MODEL: 2017 & 2018 Z900 & 900 ABS (ZR900AHFL/BHFL/BJF/BJFL)

## FRAME INSPECTION & REPAIR

### RECALL

**Frame Inspection**

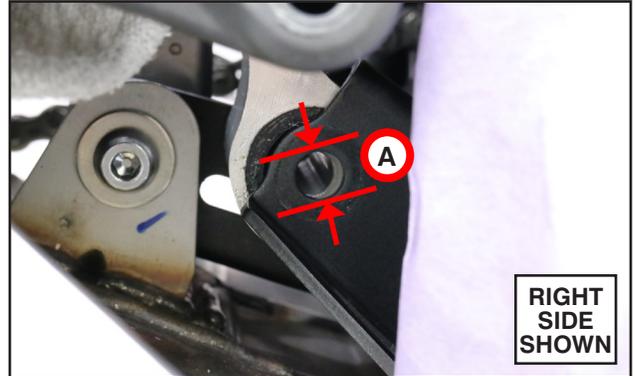
On eligible units, the rear suspension tie rod frame mount holes can become elongated if the rear shock absorber bottoms out. This can prevent the rear suspension from operating properly and could cause a crash resulting in injury or death.

- Remove and discard the tie rod nut, bolt and washer
  - Measure the elongation length [A] of the left or right tie rod installation hole in the frame along the same line as the centerline of the tie rod.
- ★ If the hole measures **16mm or less** in diameter, proceed to the “**Install Brackets**” section of this bulletin.
- ★ If the hole measures **over 16mm** in diameter or has visible cracks, proceed to the “**Replace Frame**” section of this bulletin.

## Replace Frame

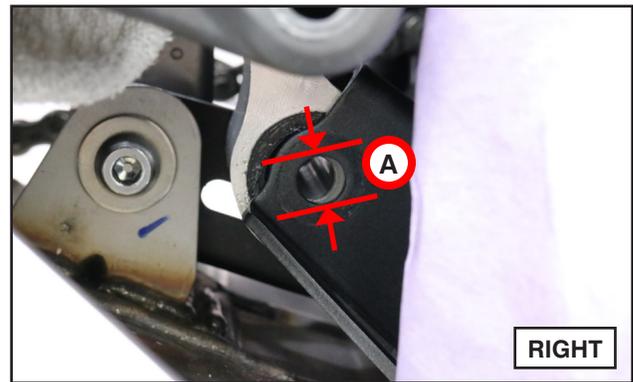
- o Only replace the frame if the hole [A] in the frame bracket measures over 16mm in diameter or has visible cracks.

- o If the frame requires replacement, contact the Product Support Hot Line at (800) 854-3800. The Hot Line will prepare the replacement frame by stamping the VIN and installing all required labels.

- Replace the frame with a new one.
- After installing all components on the replacement frame, use an appropriate cutting tool to remove the steering head with the VIN from the old frame. Ensure the VIN is not damaged during removal.
- Dispose of the remainder of the frame in accordance with all local laws and regulations. Return the "VIN" portion of the frame with a copy of your work order and the warranty claim to the following address:
